MIAMI-DADE COUNTY COMMISSIONERS ZONING HEARING

DATE: September 25, 2025
TIME OF MEETING: 9:30 AM

CURRENT ITEM	**8C1** **(The public hearing has not been held. The public hearing is subject to the rules of procedure.)**
PH:	**Z2023000526**
Applicant	**K E REYES PROPERTY MANAGEMENT, LLC.**
District	**04**
Summary of Requests	The applicant seeks to rezone the subject parcel from RU-2 (residential use) to RU-5 (semi-professional office use) in order to develop the site with an office use within the existing structure. Additionally, the applicant seeks to allow the existing structure to be located closer to the rear and interior side property lines than required, provide no wall and landscaping buffer for the proposed dissimilar use from the abutting residential properties to the north and west of the subject site, provide a reduced landscape buffer for the parking from the adjacent roadway, to permit less parking than otherwise required by Code and to permit less lot area and lot frontage that required by code.

CURRENT ITEM
K E REYES PROPERTY MANAGEMENT, LLC. Z2023000526 **BCC/District 04**

C-8

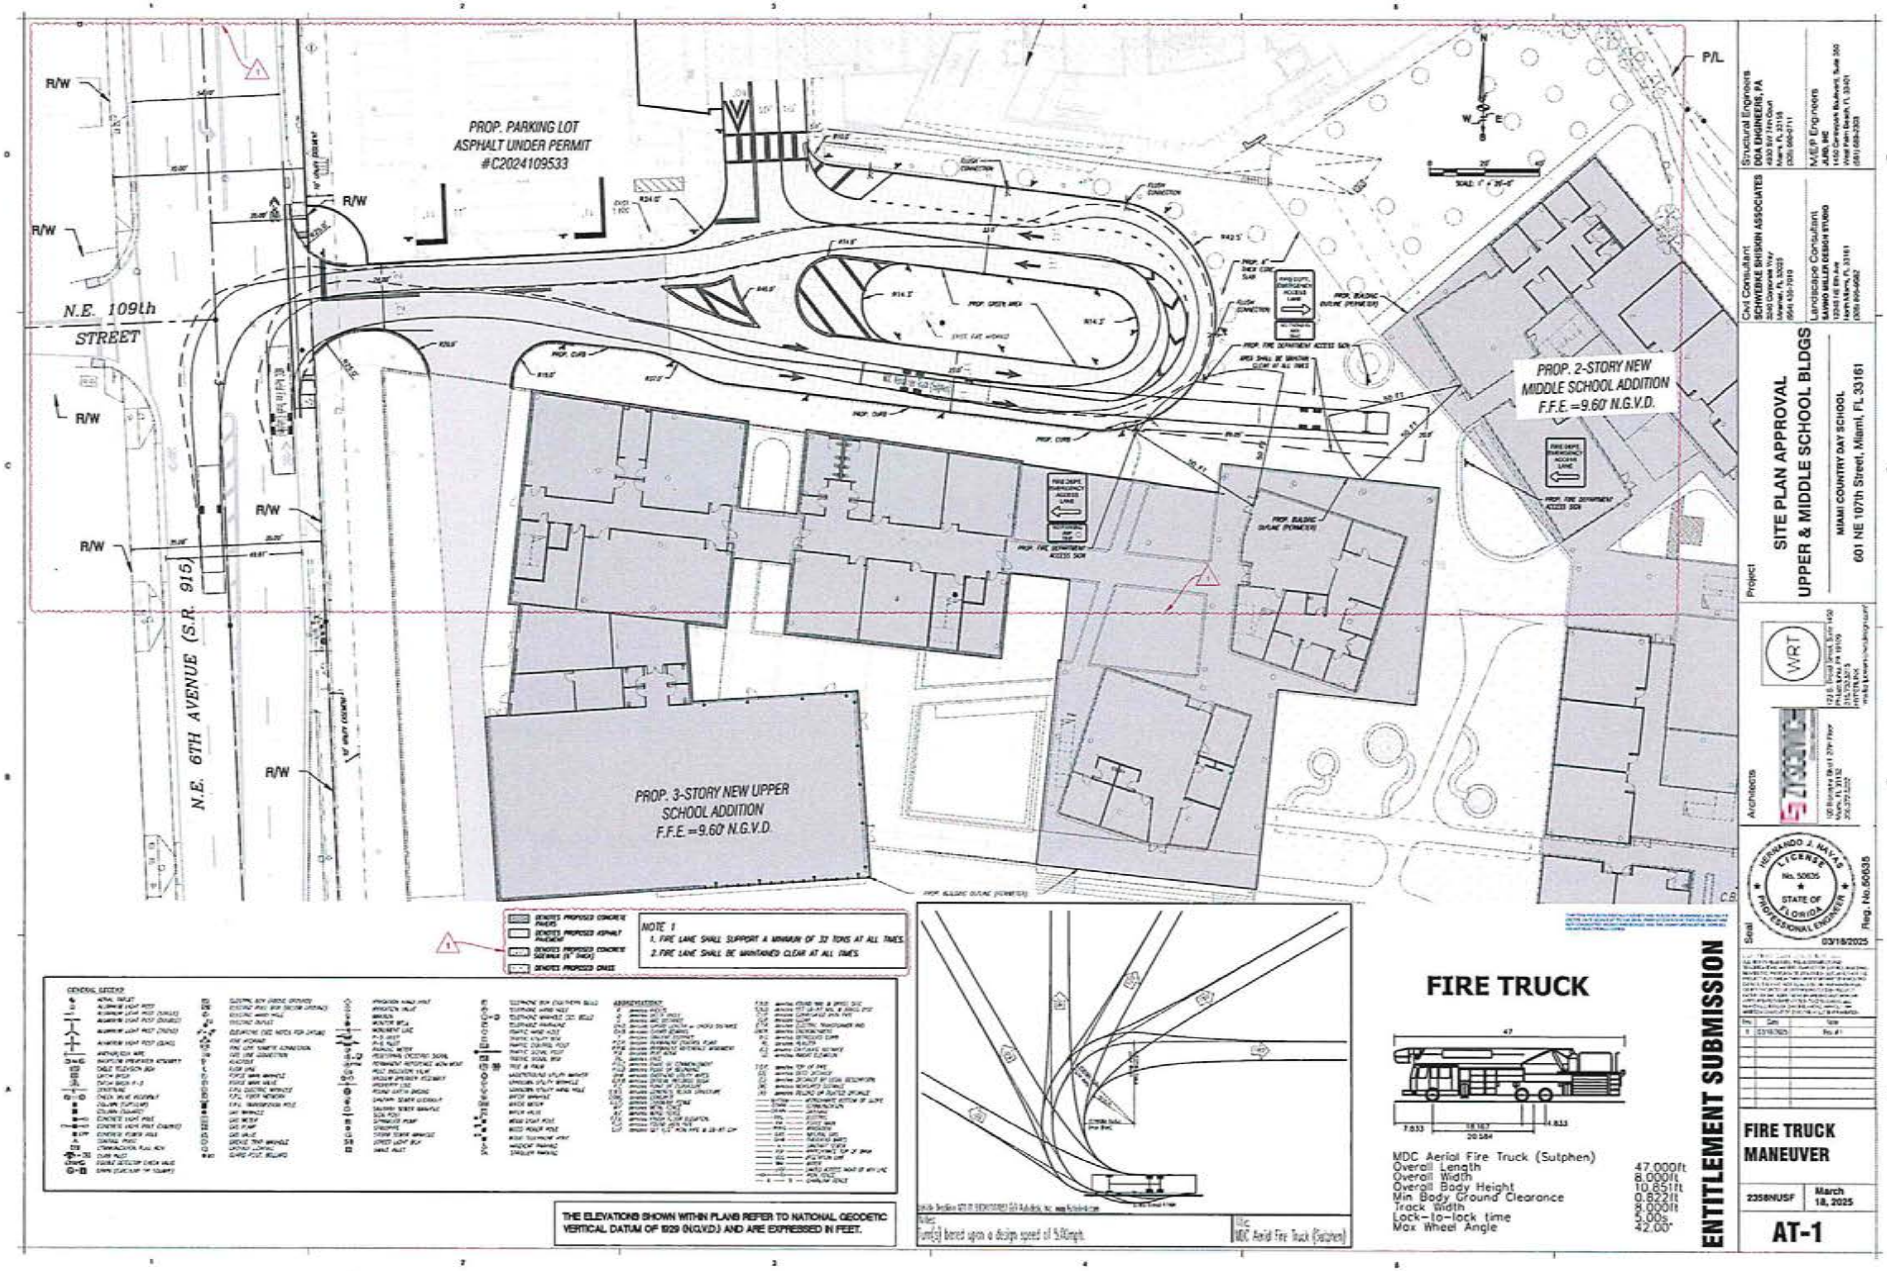
The Miami-Dade Fire Rescue Department has **no objection** to site plan uploaded to "EnerGov" on 6/03/2025. Approval based on detail provided on plan sheets C-8, AT-1 and AT-2 uploaded on 4/9/2025.
